CMD 22-M37.5

**CNSC staff update on elevated
hydrogen equivalent concentration
discovery events in the pressure
tubes of reactors in extended
operation**

Review of Bruce Power Submissions on Elevated
 Heq in Pressure Tube Rolled Joints and
 Independent Analysis of Possible Causes

Prepared by: Paul Sedran, P.Eng
 Principal, RESD Inc

Figure 3 – Axial [H], [D], and [Heq] Profiles at the Top of the Outlet PT RJ in B6S13 at 271,729 HH

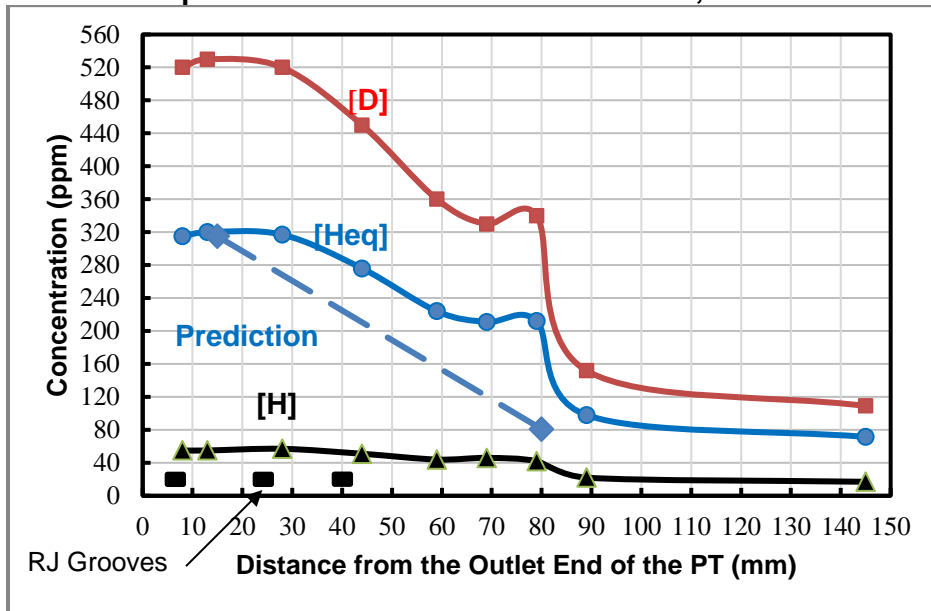
The shape of the axial Heq profile of Figure 3 is more consistent with the existence of a local source of H/D at the top of the PT than with thermal diffusion to the top of the PT. This is because the concentration profile in a thermal field will resemble the temperature profile, which would be wider and shallower than the concentration profiles of Figure 3.

Figure 3 appears to indicate the presence of a source of D and H ingress in a region at the top of the PT, ranging from 8 to 28 mm from the outlet end of the PT. That the concentration peak is limited to an axial region of the PT which is rolled into the EF implies that the peak is most reasonably attributable to diffusion from the EF into the section of the PT that is affected by the

rolling of the PT into the EF. As shown in the figure, the peak of the [H] and [D] profiles coincides with location of the most outboard RJ groove.

This suggests the possible existence of a dominant source of ingress at the outboard groove, which could be explained by local cracking of the PT oxide layer at the groove during the RJ rolling process. The cracking and subsequent plastic deformation of the could form regions of direct contact of the EF and the PT, promoting ingress from the EF to the PT.

Figure 4
Circumferential Distribution of [H], [D], and [Heq] at the Outlet PT RJ of B6S13 at 271, 729 HH

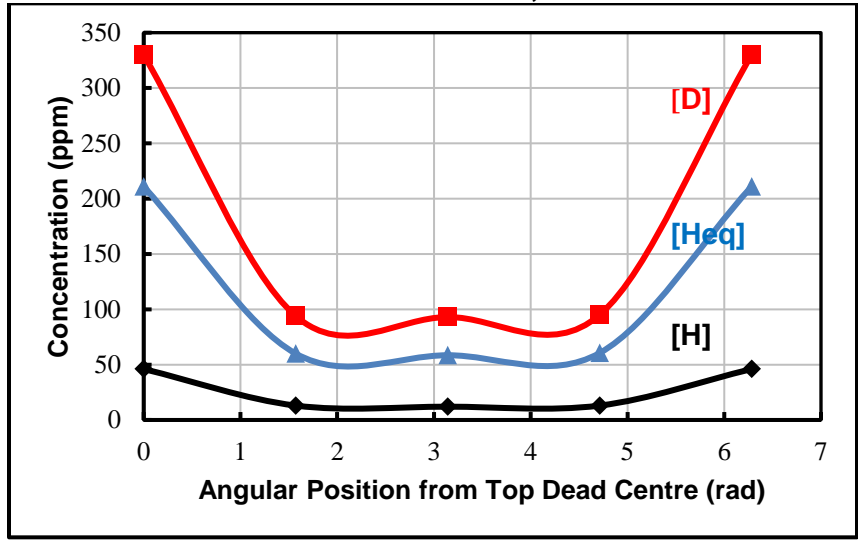
Figure 4 is a plot of the circumferential distribution of [H], [D], [Heq] at the BM for B6S13. As before, in the case of Figure 3, the shape of the circumferential distribution suggests the presence of an ingress mechanism at the top of the PT rather than a diffusion mechanism to drive H and D to the top of the PT. The circumferential concentration gradient intuitively appears to be too steep to have been created by the diffusion of H/D to the top of the PT RJ.

Figure 6
[D] Measurements versus Angular Position For the Outlet PT RJ in B6S13 and B3F16

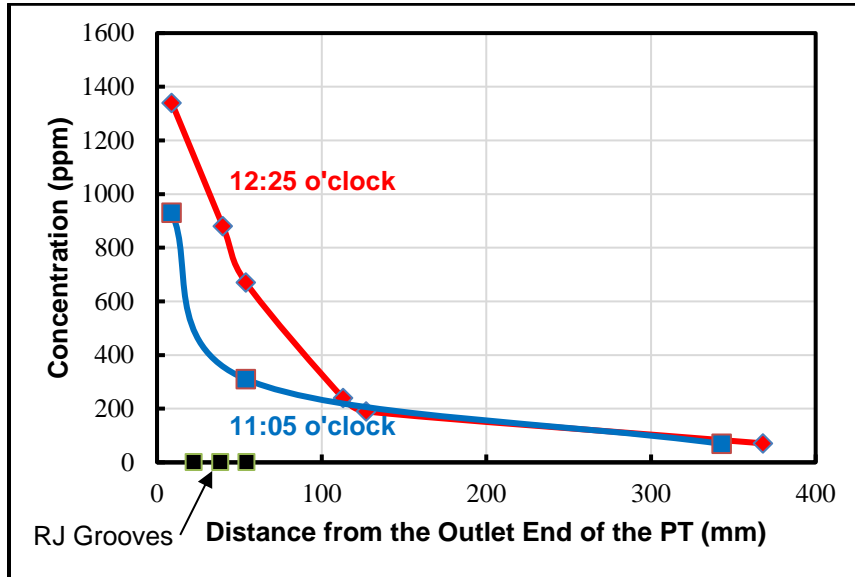
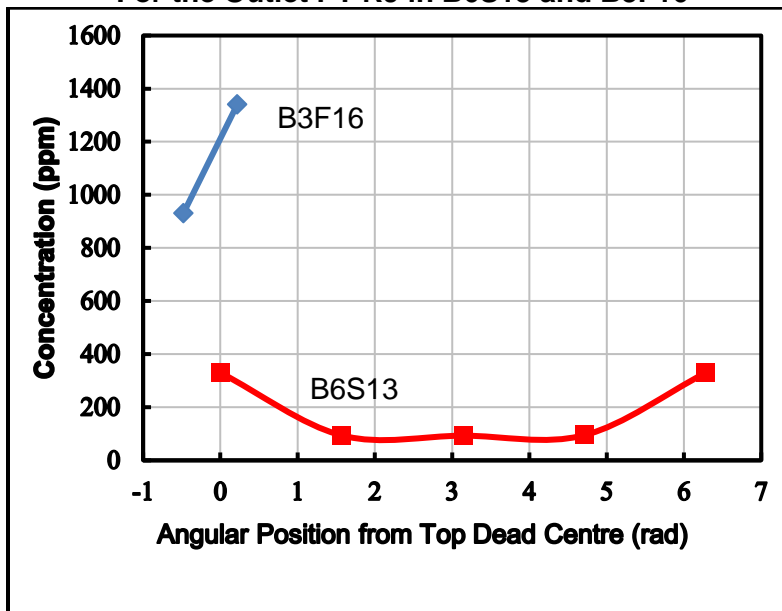
It is seen in Figure 5 that the peak of the D concentration is very localised and the concentration gradient in the axial direction is very steep in comparison to the axial gradient for B6S13 in Figure 3. Intuitively, the axial concentration gradient is too steep to be associated with a thermal gradient in the PT, to a greater extent than is shown in the B6S13 concentration measurements.

The main point derived from the comparison of the B6S13 and the B3F16 measurements is that the two circumferential [D] profiles are significantly different, whereas only minor differences are expected in the operating temperature distributions at the PT outlets of the B6S13 and the B3F16. Therefore, the differences in the shapes and magnitudes of the concentration profiles of Figure 6 are more consistent with the existence of individual, PT-specific local sources of H/D at the top of the PT than with thermal diffusion to the top of the PT.

Figure 10
Plot of Coolant Temperatures in a PT with Flow Bypass

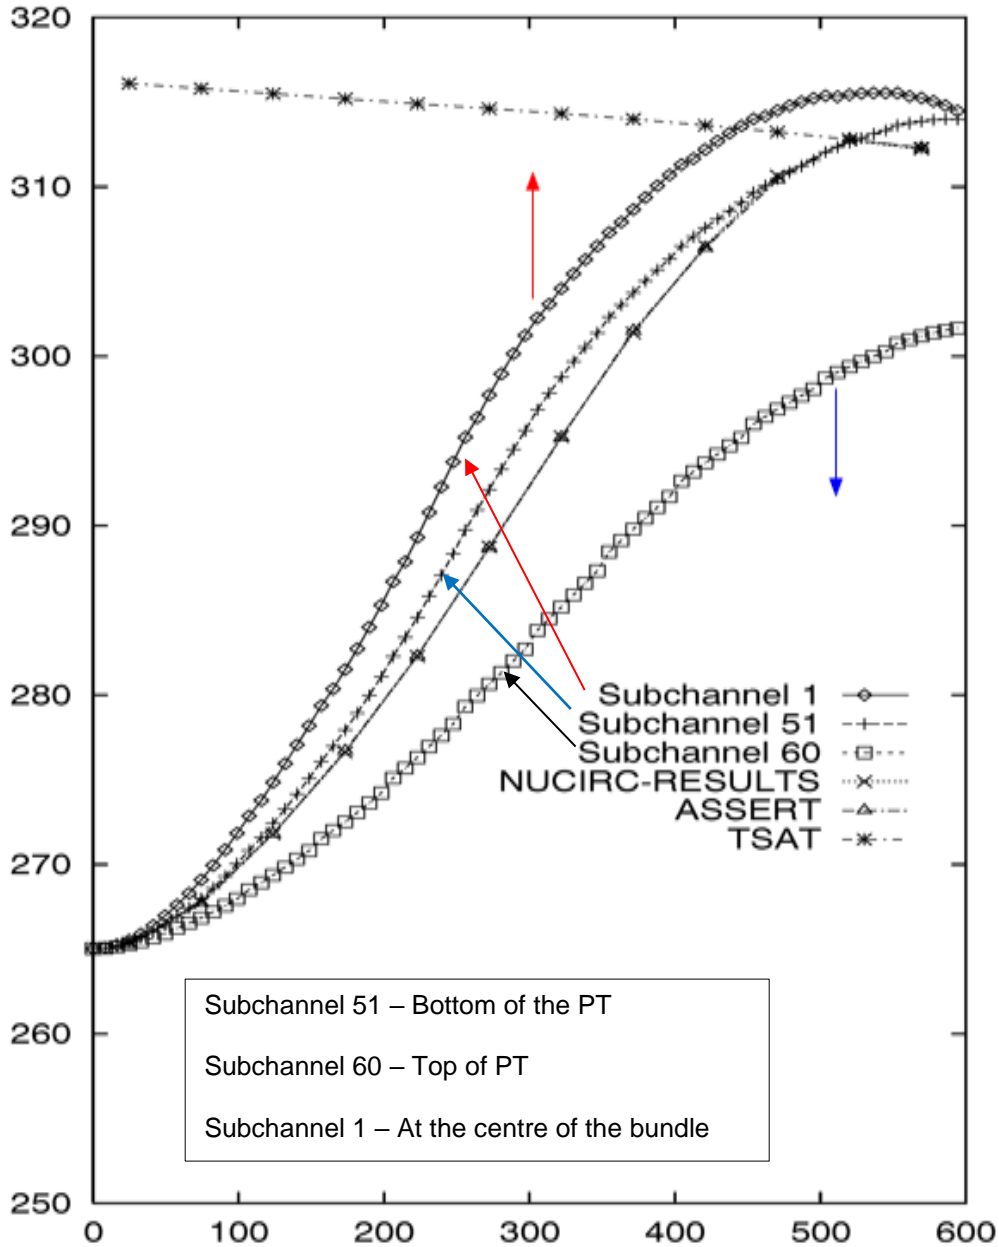
Figure 10 indicates that there would be a 12 °C difference between the top and side of the PT at the outlet due to flow bypass or 6 °C over an angle of 1.517 radians, for a temperature gradient of 8

°C/rad. From Tables 3 and 4, it is seen that, at minimum, a circumferential temperature difference of 52 °C from 0 to $\pi/2$ radians would be required to generate the concentration gradients in question.

The figure shows that in a crept PT, the coolant temperature is approximately 12 °C lower at the top of the PT outlet than at bottom of the PT outlet. From the geometry of the fuel bundle and the crept PT, it was assumed that the coolant temperature at both sides of the PT would equal that at the bottom, so that the coolant temperature would increase around the circumference of the PT by 12 °C from 0 radians (Top Dead Centre) to $\pi/2$ radians (3 o'clock). The thermal hydraulics of the PT are such that the PT temperature is assumed to be the same as coolant temperature.

In summary, the assessment of Tables 3 and 4 indicates that the minimum top-to-side temperature difference required to generate the observed concentration gradients in the B6S13 is 52 °C, compared with an expected temperature difference of 12 °C, from Figure 10.

Figure 15
[Heq] Measurements for B6S13

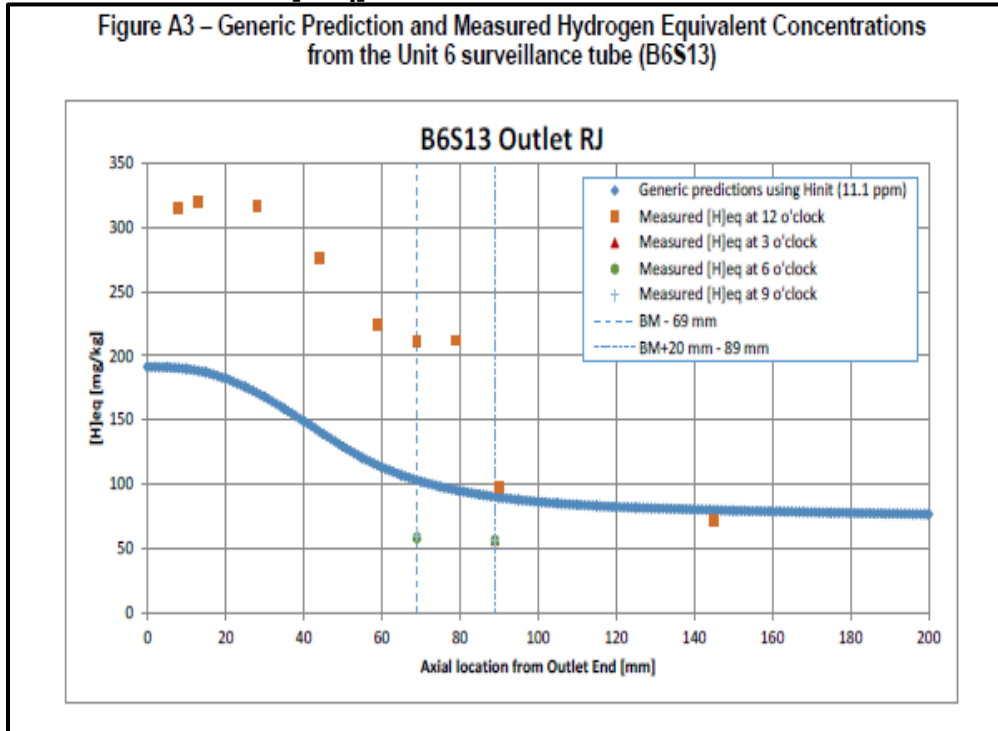
From Figure 13, the typical [Heq] value at the outlet BM for a Bruce Unit 6 PT is approximately 90 ppm, which is in reasonable agreement with the value calculated here.

The agreement between the calculated average [Heq] value and that given in Figure 15 provides some confirmation of Bruce Powers hydrogen distribution theory.

Figure 19
Expected Circumferential Temperature & Predicted [D] Profiles
For the B6S13 Outlet RJ versus Measured [D] Profile

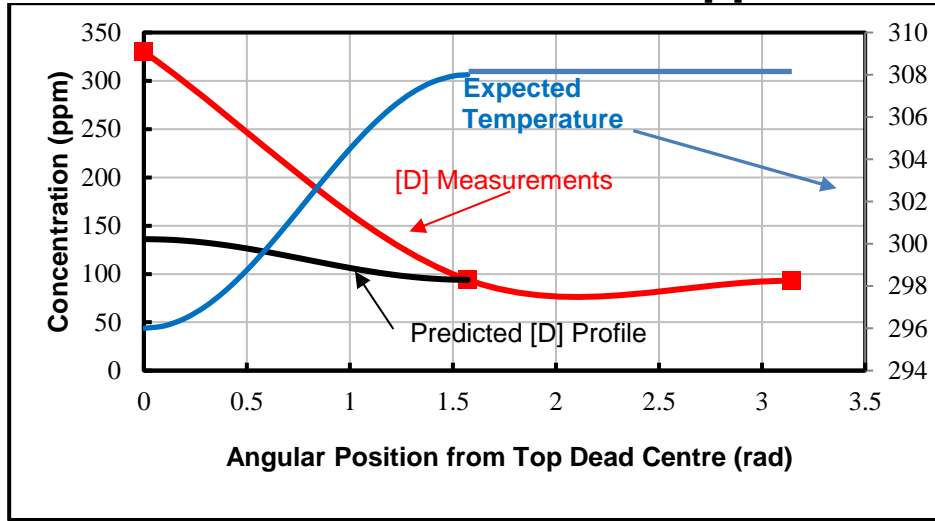
Figure 19 shows that the expected circumferential temperature profile, shown in black, could have resulted in some diffusion to the top of the PT profile but the thermal diffusion could not have generated the observed [D] profile, shown in red.

1. Based on the assessment of Section 5.1.1, the measured circumferential [H] and [D] gradients in the outlet PT RJ of B6S13 could not have been caused by thermal diffusion alone, under the expected operating temperature profile, depicted in Figure 19 (derived from Figure 10).

2. Provided that Figure 19 accurately represents the operating temperature profile of the B6S13 outlet, it follows that another diffusion mechanism, instead of thermal diffusion to the top of the PT, was responsible for elevated H and D concentrations at the top of the outlet PT in B6S13 and B3F16.

3. Conclusions 1 and 2 are dependent upon the currency and applicability of Figure 19 to B6S13. Given that Bruce Power has asserted that the thermal diffusion theory has been independently verified but no details of the verification process were provided in the documents that were reviewed, no definitive conclusion about the thermal diffusion theory will be drawn at this time.
